SERVICE BULLETIN

GLOBAL AFTER SALES OFFICE, MITSUBISHI MOTORS CORPORATION

PURPOSE : CHANGE	ISSUE NO.: MSB-14EXL13-001	DATE: 2014-04-16	
SUBJECT: TROUBLESHOOTING REGARDING DPF		<destination model=""> (As per attached sheet 1)</destination>	<m y=""></m>
GROUP : DIESEL FUEL(G

Please refer to the attached document for the information about the change of mention in the applicable service manual.(The following troubleshooting regarding DPF have been changed)

Code No. P0101: Air Flow Sensor Performance

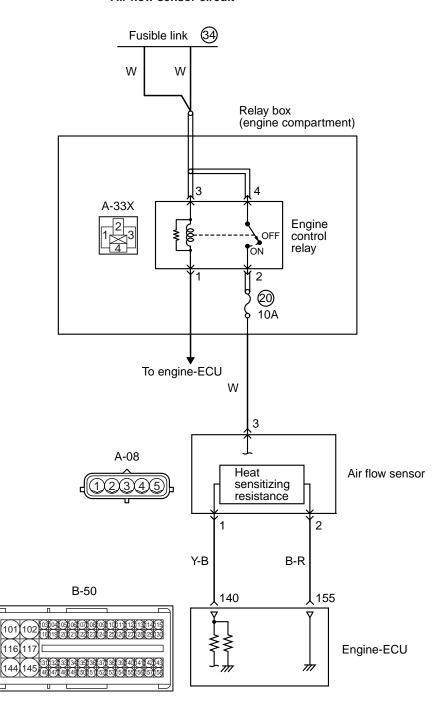
Code No. P0101: Air Flow Sensor Range/Performance Problem

- Battery positive voltage is 8 16 V
- 1 second before the throttle valve fully openedposition value after the ignition switch has been in

• The air flow sensor output voltage is threshold value or less.

The air flow sensor output voltage is threshold value or more.

<Added>

Code No. P2453: Exhaust Differential Pressure Sensor Range/Performance Problem

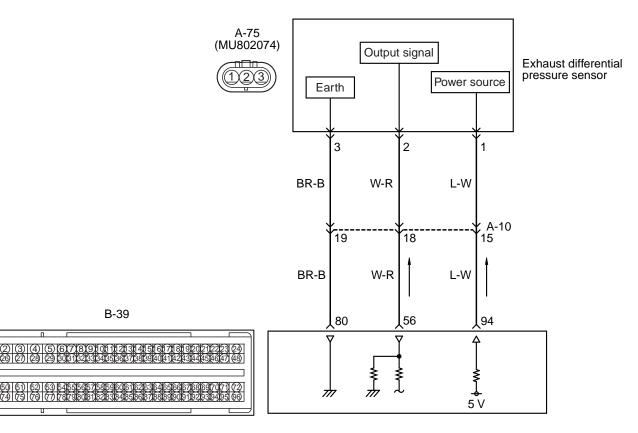
Code No. P2453: Exhaust Differential Pressure Sensor Range/Performance Problem

The exhaust differential pressure sensor output voltage is less than threshold value based on exhaust gas flow for predetermined time.

• The exhaust differential pressure sensor output is more than 2.75 kPa for predetermined time.

• The exhaust differential pressure sensor output is less than –2.75 kPa for predetermined time.
